Our Reference
60547247 (432)

Town of Inuvik - Municipal Solid Waste Disposal Facility (MSWDF) Operations and Maintenance Manual - Review Comments

Figure 1: Solid Waste Facility Capacity (O&M Manual)

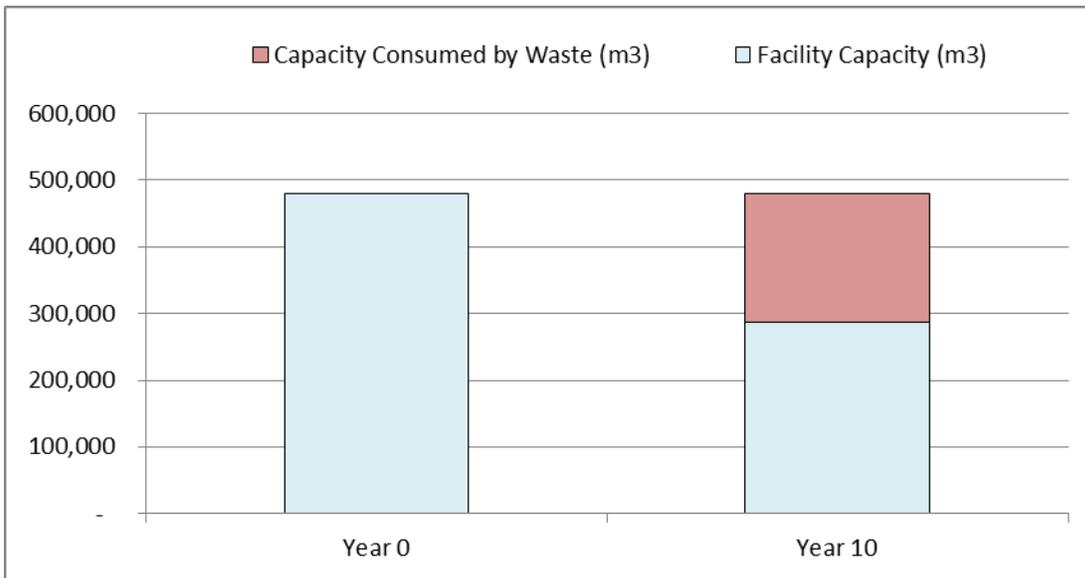
- v. When it's explained that the space needed for the next 10 years is 193,873 cubic metres, would you be able to showcase that in map form. It's hard to get a sense of the scope when it's just a number. Also when it's mentioned that the overall capacity of the landfill is 480,000 m² and this exceeds the estimated space available for the next 10 years, having a map to illustrate this scope would be beneficial.

The O&M manual states there is 480,000 cubic metres (m³) of capacity (volume) available at the site and that over the next 10 years an estimated 193,873 m³ of that available capacity (volume) will be consumed (filled with waste over those 10 years). To illustrate this consumption relative to the capacity, I've provided **Figure 1**.
